TELEDYNE CONTINENTAL® AIRCRAFT ENGINE

M89-23 Technical Portions Are FAA Approved

SUBJECT: TSIO520CE LOWER THROTTLE BODY SUPPORT BRACKET AND

LINKAGE

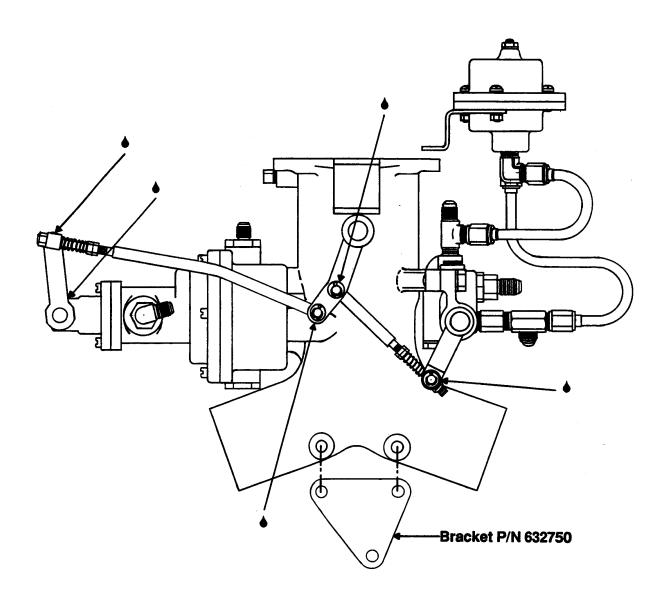
It has come to our attention through service tests conducted at Cessna Aircraft Corporation on the TSIO520CE engine that premature wear of the pin joints of the throttle and controller linkage has occurred. These pin joints should be inspected very carefully for wear and any necessary repairs be made.

In order to alleviate this premature wear, remove and discard the lower throttle body support bracket, P/N 632750.

Removal of this support bracket will reduce the vibration levels exerted on the controller and throttle linkage, and will in no way be detrimental to the operation of your engine.

NOTE...Lubrication of the linkage and controller cam must be accomplished at 100 hour inspections using clean 50 weight engine oil.
